CENTER for SCIENCE in PUBLIC PARTICIPATION

August 15, 2022

Re: **BC EAO EAC Tenas Project Application – Comments on Management Pond Dams**

Figure 1-2: Management and Control Pond Site Plan

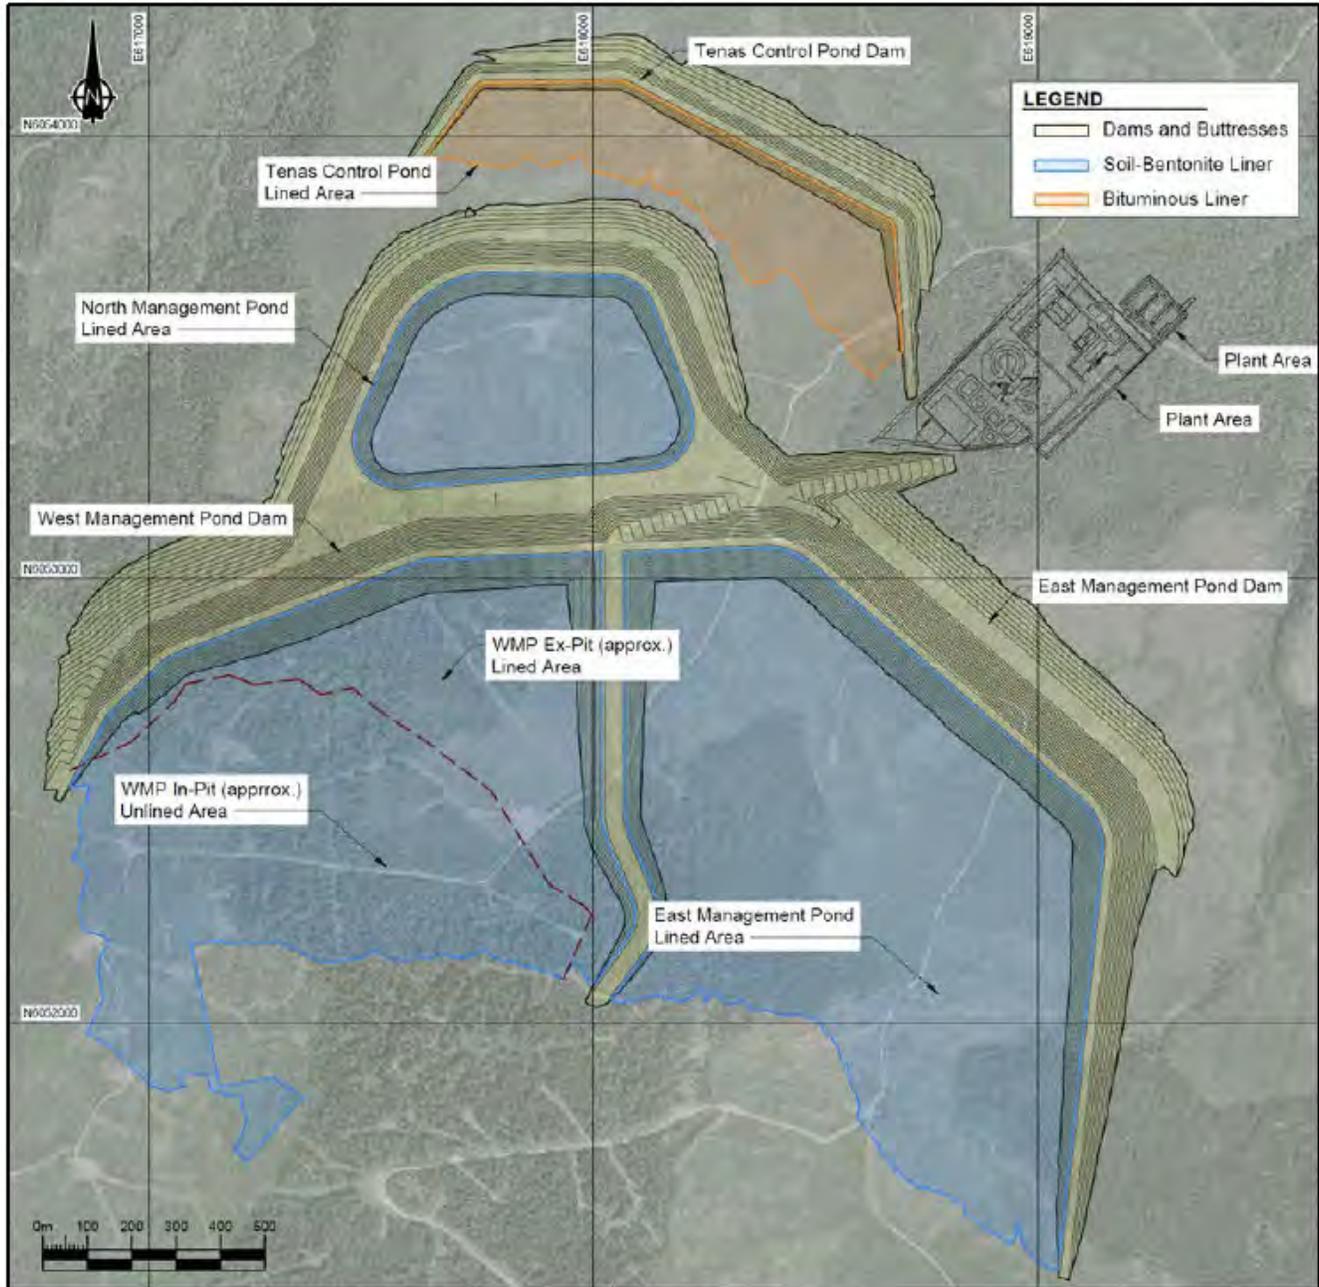
There are three Management Ponds proposed for the Tenas Project (Figure 1-2). These ponds will contain potentially acid generating waste rock, as well as the fine processing waste from cleaning the coal. During mine operation the Management Ponds will have a water cover to minimize the production of contaminants from the waste material. The East Management Pond dam, at 40 meters in height, is the same height as the failed Mount Polley tailings dam. The West Management Pond dam is 37 meters in height. During mine operation there is also the Tenas Management Pond, used for water management, which will be decommissioned after mine closure.

A fundamental design flaw for these dams is that they are in a cascading configuration (Figure 1-2). That is, the East and West Dams are located directly above the North Dam, and these three dams are located above the Tenas Dam. The failure of an upper dam, especially the West Dam, could also lead to the failure of a lower dam, making the results of the failure much more severe. During its participation in the development of the Global Industry Standard on Tailings Management, the United Nations Environmental Program strongly discouraged the use of cascading dams (UNEP 2020). A cascading dam failure at Stave, Italy, in 1985, led to one of the largest loss of life incidents caused by a tailings dam failure. Cascading failures were not modelled as a part of the Dam Breach Assessment.

The need for reassessment for seismic design, additional testing to assess whether the foundation and dam construction materials are of sufficient strength to use and support the construction of a dam, and the use of a dangerous cascading dam configuration, all suggest that the fundamental redesign of these waste disposal facilities is warranted.
